Customer : CU-DAR001 Dart Helicopters Services	Drawing Name : HELI UTILITY BASKET LH/RH 350/355
Job Number : 45949	
Estimate Number : 10208	
P.O. Number :	Part Number : D350607043
This Issue : 23/02/2009 S.O. No. :	Drawing Number : D350-607 REV F P7-9
Prsht Rev. : NC	Project Number : N/A
First Issue : / / Type : LARGE FAB ASSY	Drawing Revision : F
Previous Run : 45368	Material :
Written By :	Due Date : 03/03/2009 Qty: 1 Um: Each
Checked & Approved By : JLD 09.02.23	
Comment : Est Rev:E as Per DSI9318 06-01-24 JLM Est Rev:F ECN1068 07-12-21 DD verified by:

DESIGN <i>CP</i>	DRAWN BY <i>CP</i>	DART AEROSPACE LTD HAWKESBURY, ONTARIO, CANADA	
CHECKED <i>[Signature]</i>	APPROVED <i>[Signature]</i>	DRAWING NO. DSI 9318	REV. A SHEET 1 OF 1
DATE 06.01.06		TITLE WASHER ADDITION	SCALE NTS
A	06.01.06	NEW ISSUE

DART SERVICE INSTRUCTION

TO AMEND INSTALLATION INSTRUCTIONS D350-607 REV. F

Figure 5- Basket Replacement Parts
(D350-607-043 Heli-Utility-Basket™)

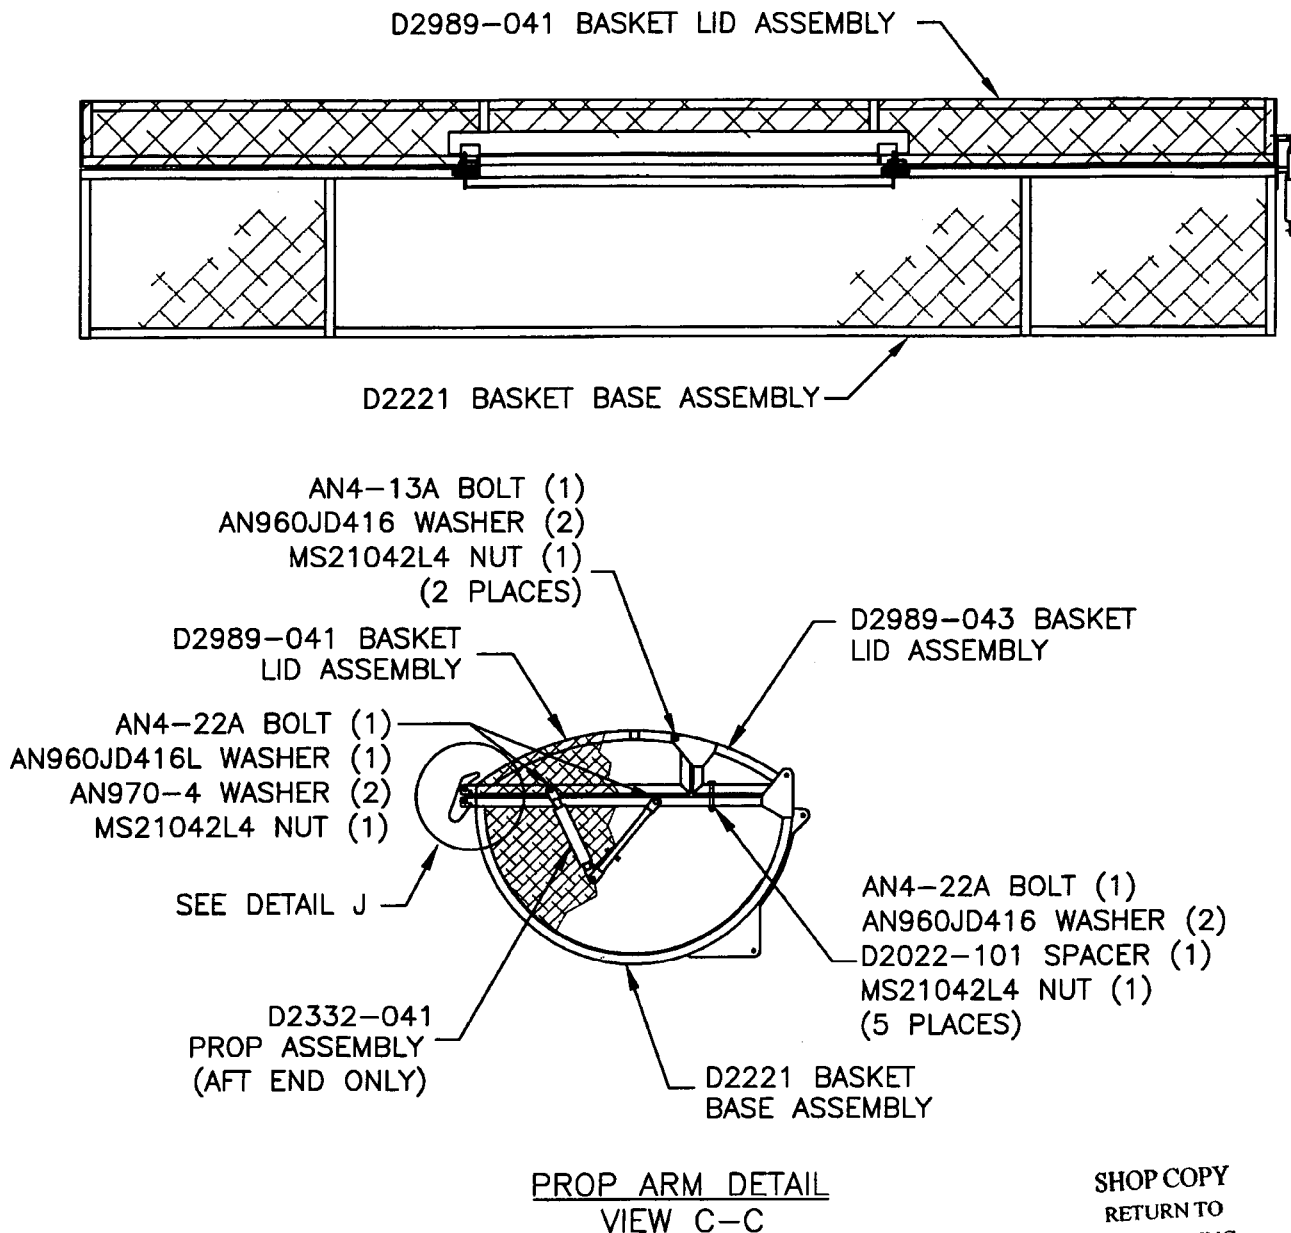
To reduce the possibility of damaging the finish, a **NAS1515H4** washer (2 places) has been added between the hinge plate and basket frame on the **D350-607-043/-047 Heli-Utility-Basket**.

The corrected bolt stackup from Figure 5 of installation instructions D350-607 Rev. F is given below:

AN4-13A BOLT (1)
AN960JD416 WASHER (1)
HINGE PLATE (REF)
NAS1515H4 WASHER (1)
BASKET FRAME (REF)
AN960JD416 WASHER (1)
MS21042L4 NUT (1)
(2 PLACES)
